PROJECT TITLE :
Proposed LIDL store on Richmond Road Twickenham

DRAWING TITLE :
Planning 04 West Elevation Comparison

West Elevation Planning Drawings

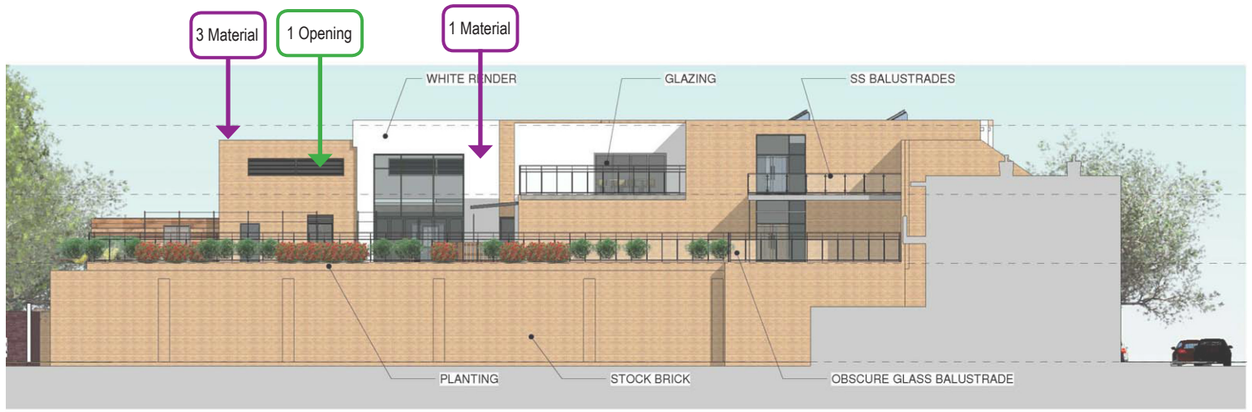
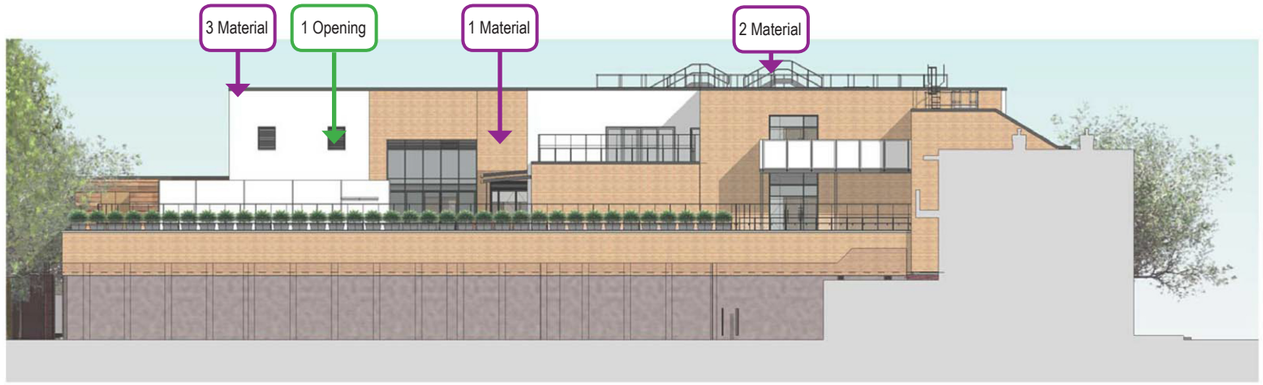
1 Proposed Change: Window / louvre design rationalised and aligned.
Reasons: Opening rationalized to suit revised elevation and CDM requirement.

1 Proposed Change: Cladding changed to brick.
Reasons: Render replaced to create differentiation with plant room.

2 Proposed Change: Guardrail and man-safe design incorporated.
Reasons: Guard rail and man-safe system required to satisfy current Health and Safety statutory regulations.

3 Proposed Change: Roof and parapet levels rationalized.
Reasons: Roof levels simplified to allow easier roof access. Parapet levels adjusted to suit.
